July 18, 2008

MEMORANDUM

SUBJECT: Permit Renewal Staff Analysis: Mack's Inn Wastewater Treatment and Reuse Facility; LA-000057-3

Figure 4.1 Wastewater Influent Volumes

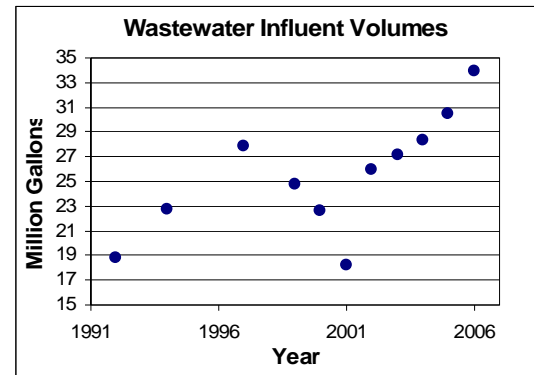
Metered influent flow data exists for the years shown in Figure 4.1. Although influent volumes are increasing steadily, the year 2006 influent volume of 33.9 MG may be higher than typically expected due to inflow resulting from an excavated sewer line, resulting in groundwater inflow.

The facility is permitted to remove 44.35 MG of wastewater (28.35 MG irrigated + 16 MG snowfluent), in addition to 1.25 to 2.5 MG evaporated; the total is approximately 12 MG disposal capacity beyond the 2006 influent volume.

Figure 4.4 Soil Phosphorus

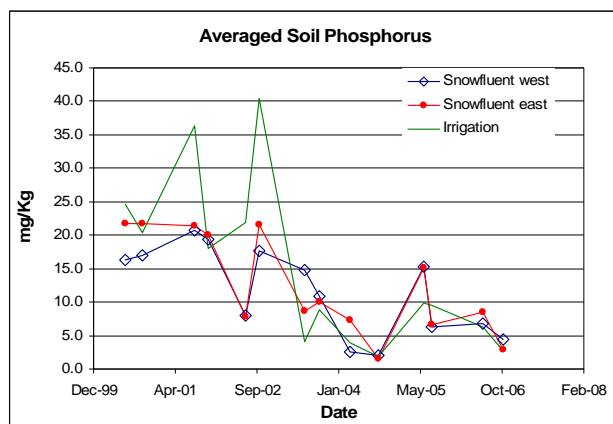
Previous analyses of the facility have expressed concern for phosphorus buildup in the snowfluent area soil, or leaching at the snowfluent sites due to the high hydraulic loading rates. Monitoring has not indicated phosphorus buildup or breakthrough (Figures 4.4 and 4.5).

Figure 4.7 Snowfluent Units Ground Water Nitrate

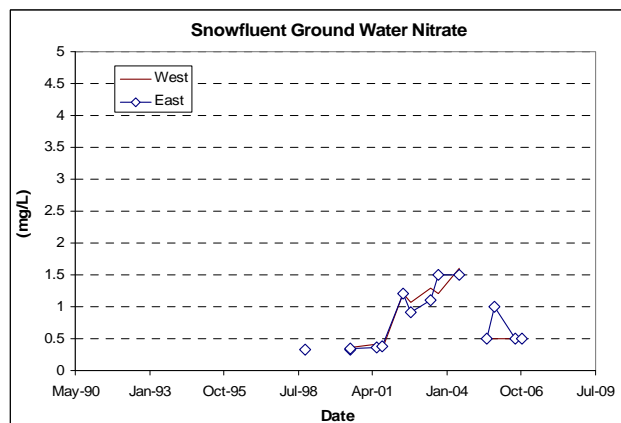
Ground water nitrate levels are analyzed twice per year, and do not indicate any ground water standard violations.
